Service Bulletin

SB 06-9-20

Applies to: All RV's with manual trim and all RV-10's.

Synopsis: An improved WD-415-1* manual trim cable anchor has been designed and is being made available by Van's Aircraft at a modest price. The new anchor has closer angular tolerances and is substantially stronger than those previously supplied.

Figure #1

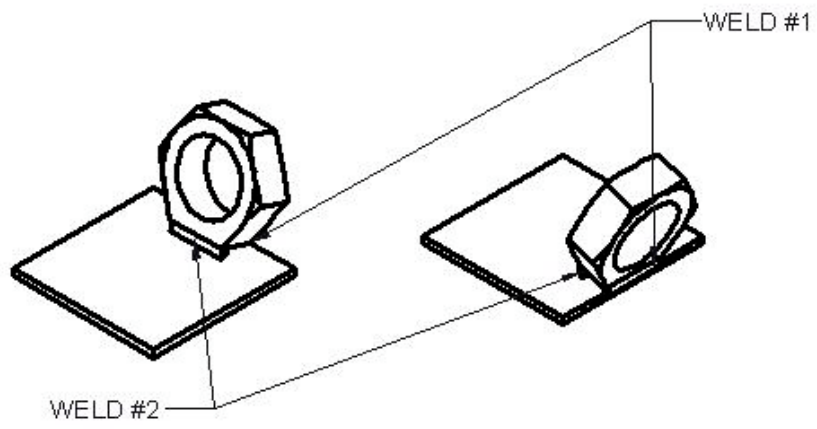
Identification information: Figure #1 below depicts the new anchor, WD-415-1. WD-415-1 anchors can be identified by full width welds on both sides of the nut.

Affected WD-415's are identified by either no aft weld (single weld across the front of the nut) or one long weld across the front of the nut and a small tack weld on the aft side of the nut.

Suggested action: Van's Aircraft recommends that builders and owners of single and two place RV's with manual elevator trim and all RV-10 builders and owners replace older style WD-415 anchors with the WD-415-1 anchor. An entry in the aircraft's airframe log should be made referencing this replacement.
